ADDENDUM No. 2
REQUEST FOR TENDER Ariba Doc4730560274
CLOSING DATE: 12:00 NOON (LOCAL TIME), February 28, 2025

For: The Interior Demolition of Building Located at 67 Adelaide St. E

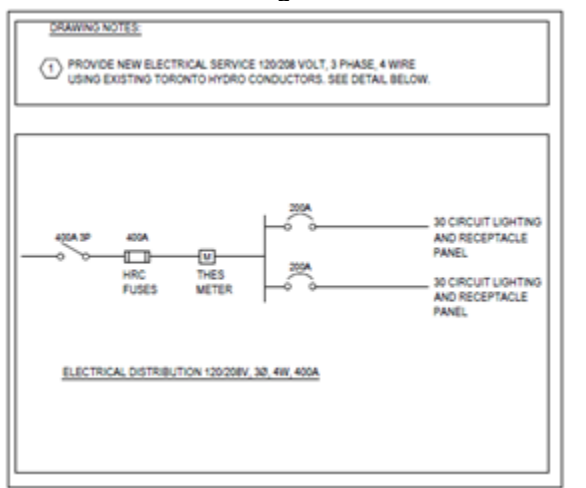
Q5 – In the summary of work note below, new lighting, electrical panel and electrical system were mentioned (see below) but none were shown in the drawings. Only demolition drawings were found.

A5 – Electrical panel is answered in Q1, new lighting is these symbols; refer to temporary facilities requirements in Specification Section 01 52 00.
